Truxxx Manufacturing LLC  
810 E 19<sup>th</sup> Street, Tucson, AZ 85719  
Toll free at 888-660-5892 - Fax: 520-623-1663  
See our products online at <http://www.truxxx.com>

**RE: Recall (08E-026):** Truxxx Manufacturing, LLC Customer Notification and Instructions for Replacement/Reimbursement.

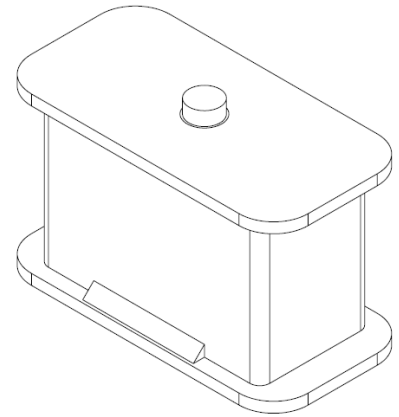
Truxxx Manufacturing, LLC (“Truxxx”) has decided that a defect which relates to motor vehicle safety exists in certain welded 3” lift blocks, part #206073 sold as replacements or included in Truxxx™ 2005-2008 Ford F-250 Superduty 4x4 suspension kits # 108035, 108036 sold between approximately July 26, 2007 and March 4, 2008. (See block illustration below). This notice is intended to advise you of Truxxx™ recall of these welded rear suspension blocks and provide instructions for replacement/reimbursement of the affected parts at no cost to you. We also ask you pass along a copy of this notice to end customers who may have purchased these kits and advise Truxxx™ at 800-381-8320 or [info@truxxx.com](mailto:info@truxxx.com) with the names of any customers you have been unable to contact.

**REASON FOR THIS RECALL:** Truxxx™ has decided that compressive forces on the welded lift blocks resulting from foreseeable and excess vehicle payloads as well as over-tightening of the u-bolts during installation may distort the blocks, reducing the intended clamping force of the U-bolts. Loosened u-bolts may allow possible shifting and damage to the rear drive shaft and axle.

**To prevent loss of vehicle control, risk of crash, injury and damage, inspect rear lift blocks and u-bolts before further use of your truck. Do not drive **any** truck with bent or distorted lift blocks until replacement blocks are installed per this recall. If lift blocks are undamaged, inspect and re-torque u-bolts to 75 ft/lbs. Replace all welded lift blocks as instructed below.**
